Green Square to Ashmore Connector Road

Response to Submissions Report

November 2018

Figure 51 SSD assessment for Botany Road – Connector Road intersection

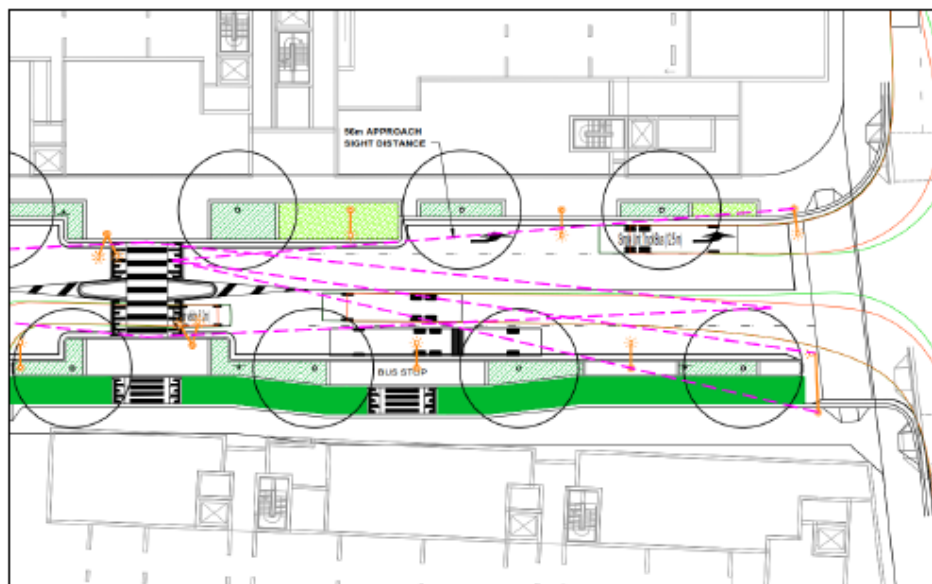
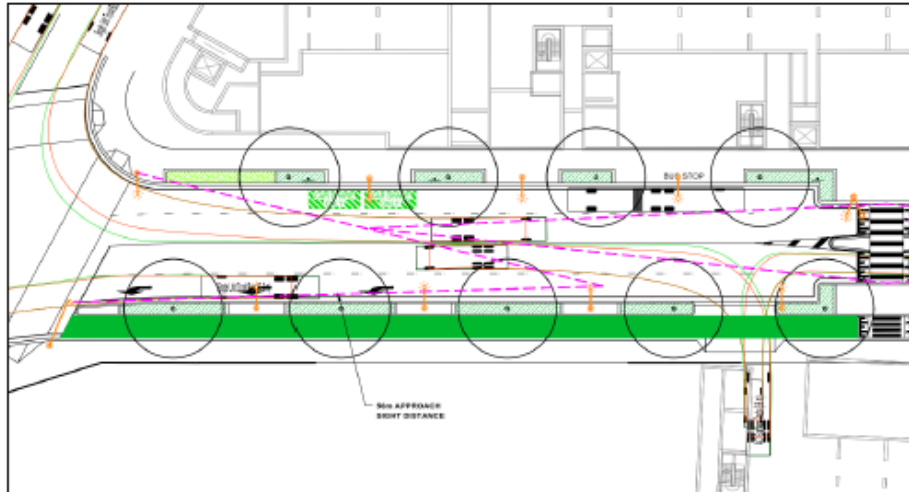
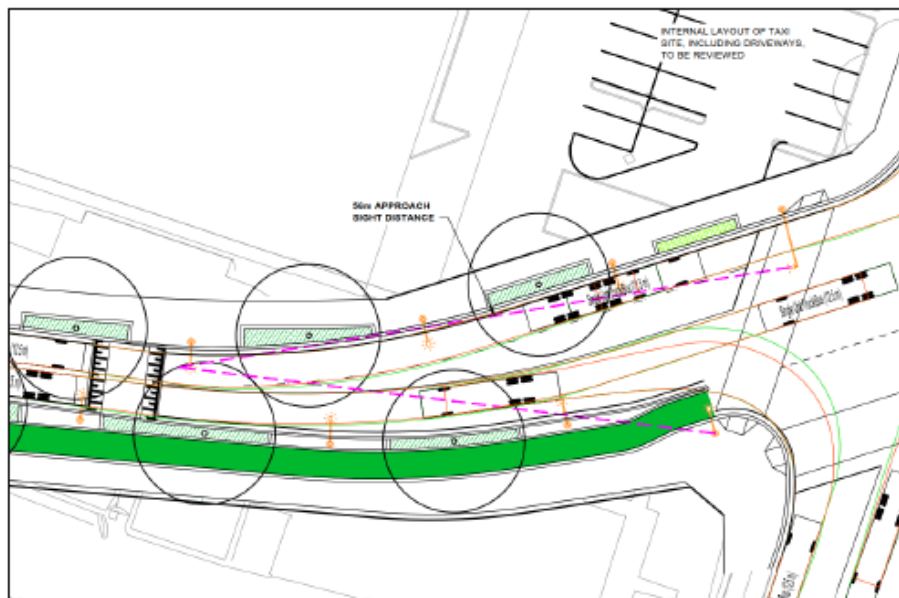
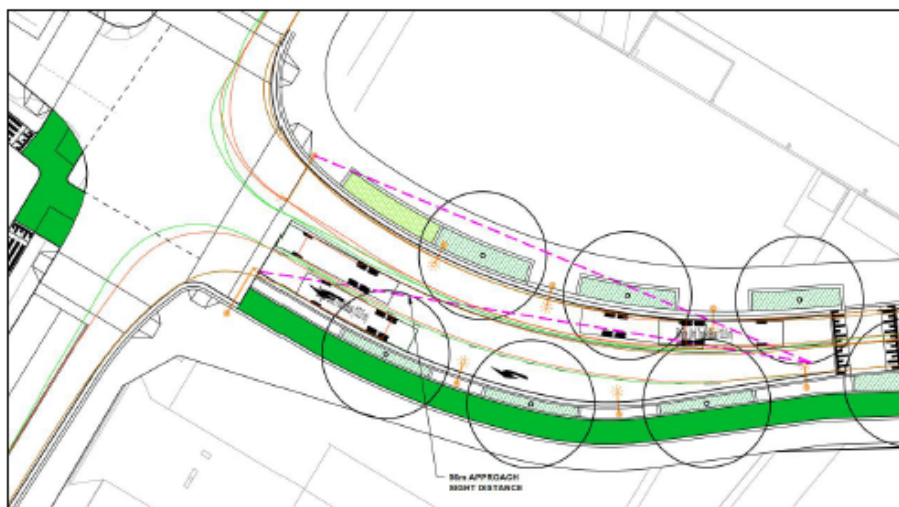
Matter Description: Trees are proposed along the length of the Connector Road. Appropriate trees should be planted to ensure the proposed traffic signals are not obscured and clear lines of sight to pedestrians are provided.

It should be noted that the City will require RMS approval of the proposed traffic signal plans before any works can commence.

Response: The proposed street tree layout presented in the Concept Design has been informed by a preliminary review against the stopping sight distance (SSD) requirements to the signals. An SSD of 56m has been adopted for a 50km/hr posted speed (60km/hr design speed) based on “Alert Driving Conditions” and a reaction time of 1.5s which is considered appropriate for a dense urban location such as this. (Refer to Figure 51 to Figure 54, Traffic and Transport Impact Assessment.)

Based on the visibility plays it would be necessary to include outreaches on a number of the signals (primarily due to the location of the cycle path (with the same detail being required on Geddes Avenue and Zetland Avenue). Including the outreaches, the required visibility displays can be incorporated in each location including the proposed trees, noting that pruning may be required until the required clear stem height has been achieved. Some pruning of trees may be required prior to sufficient clear stem height being achieved.

Drawing issued on 30/4/2018 to RMS (60300384-SKE-02-06-G-0039, 60300384-SKE-02-06-G-0040)

It is noted RMS approvals are required for signal plans. Plans and approvals will be developed and submitted during the design development stage of the project.

Figure S27. Proposed pedestrian crossing

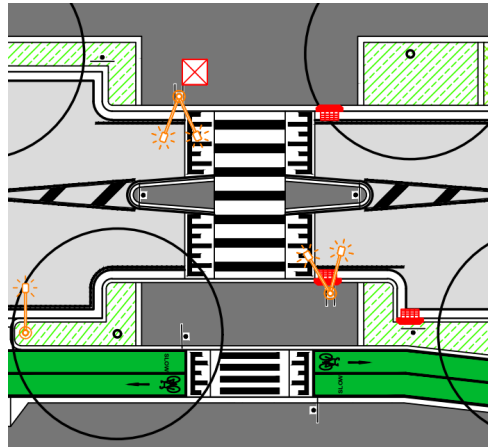
Matter Description: Median on the Connector Road east

Response: This represents the median shown around the pedestrian crossing, as shown at Figure S27 below.
